RESPONSE TO REQUEST FOR ADDITIONAL INFORMATION

APR1400 Design Certification

Docket No. 52-046

RAI No.: 155-8167
SRP Section: 06.02.05 – Combustible Gas Control in Containment
Application Section: 6.2.5
Date of RAI Issue: 08/18/2015

Figure 2.11.4-1 Containment Hydrogen Control System Functional Arrangement

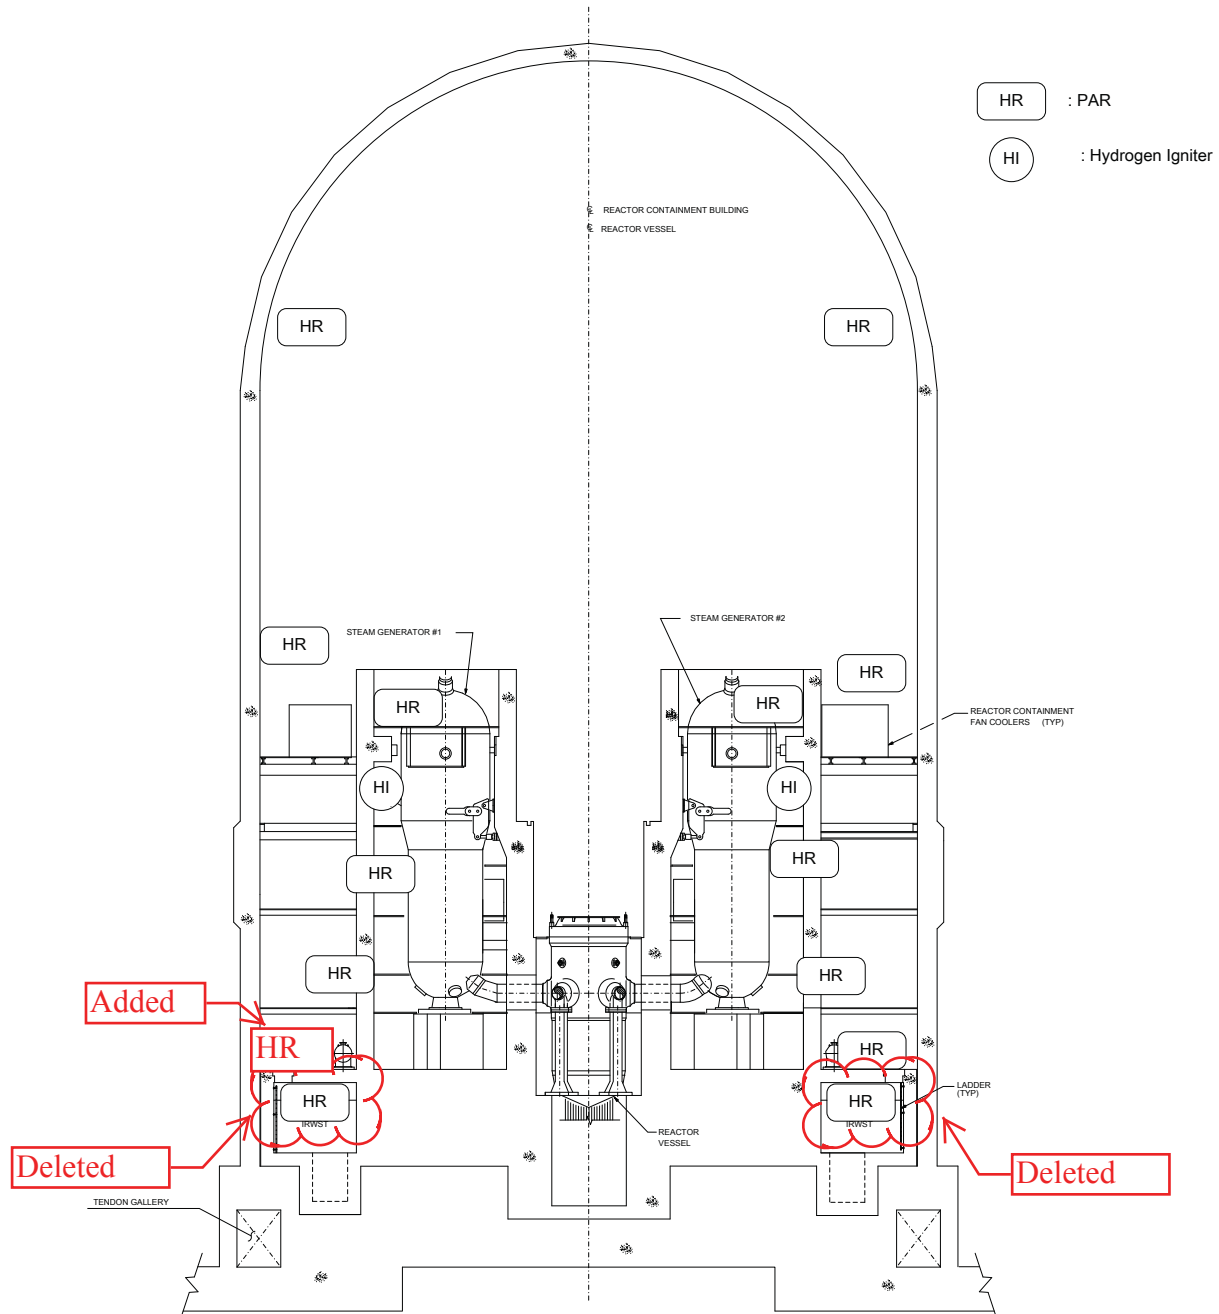
- Tier 2, Section 6.8.2.2.5, “IRWST Pressure Devices,” states “The PARs are located at the vent stack area to prevent an accumulation of hydrogen in the IRWST.”
- Tier 1, Figure 2.11.4-1, “Containment Hydrogen Control System Functional Arrangement”, shows some PARs inside the IRWST.

Please clarify the location of the PARs with respect to the IRWST and revise all the affected DCD text, tables, and figures accordingly.

Subsection 6.2.5.2.1, 6.8.2.2.5, Table 6.2.5-1, and Table 19.2.3-1 in DCD Tier 2 will be revised to indicate the PARs are located “inside the IRWST vent stack”, and the PARs location in Figure 2.11.4-1 and Figure 19.2.3-1 will be revised from the IRWST to inside the IRWST vent stack, as indicated in Attachment 2 of this response. In addition, the IRWST vent stack will be added to Figure 6.2.5-1.

In DCD Tier 2, Subsection 6.2.5.2.1 and 6.8.2.2.5, Table 6.2.5-1 and 19.2.3-1, Figure 2.11.4-1, 6.2.5-1 and 19.2.3-1 will be revised as indicated in Attachment 2 of this response.

Figure 6.2.5-1 Containment Hydrogen Control System

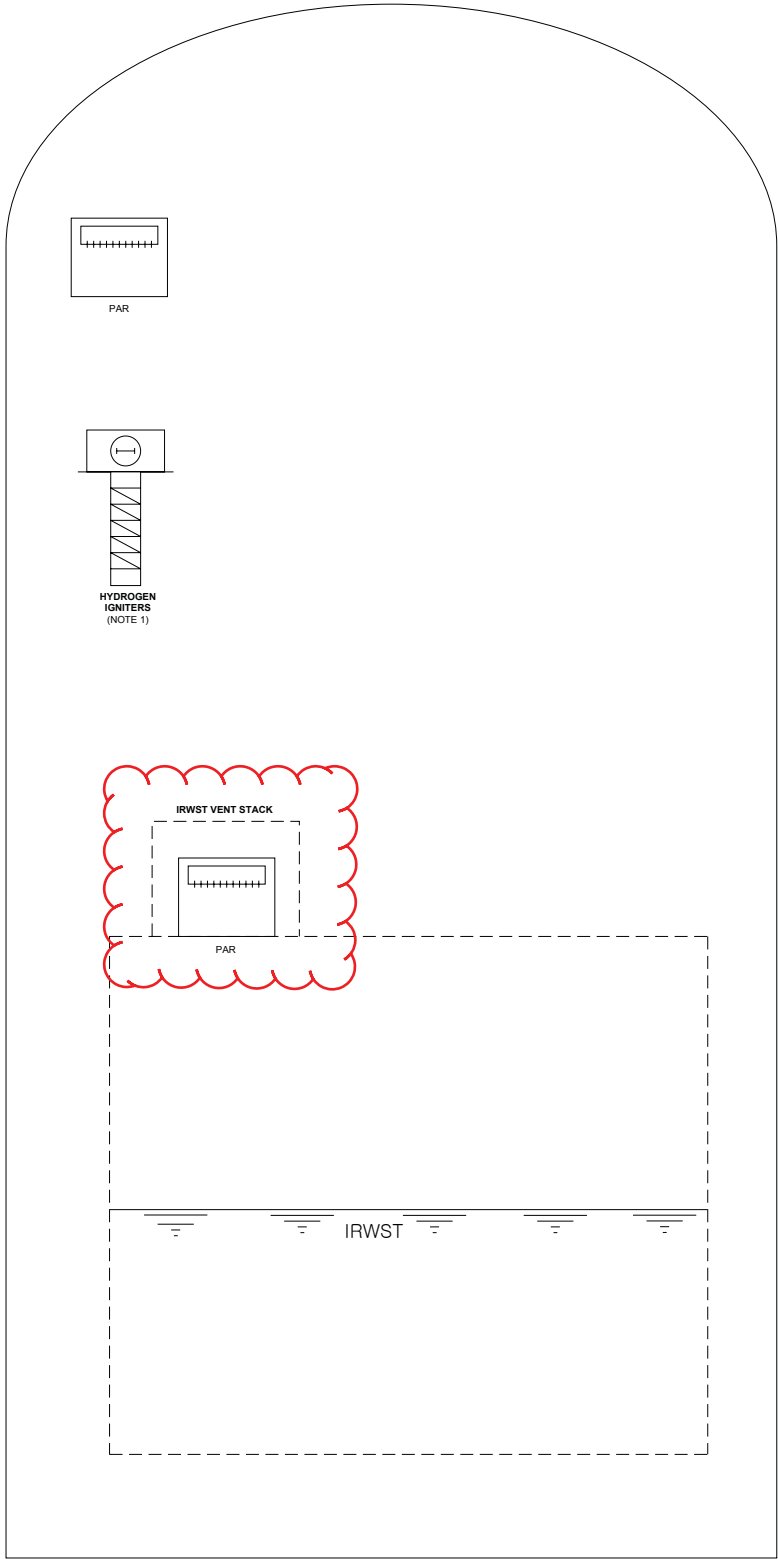
- Tier 2, Section 6.2.5.2.1 describes PAR(s) inside the IRWST.
- Tier 2, Table 6.2.5-1 identifies 4 PARs at the IRWST vent stack area.
- Tier 2, Figure 19.2.3-1 and Tables 19.2.3-1 and 19.2.3-2 indicate that 4 PARs are inside the IRWST.
- Tier 2, Figure 6.2.5-1 shows the PARs outside and above the IRWST.
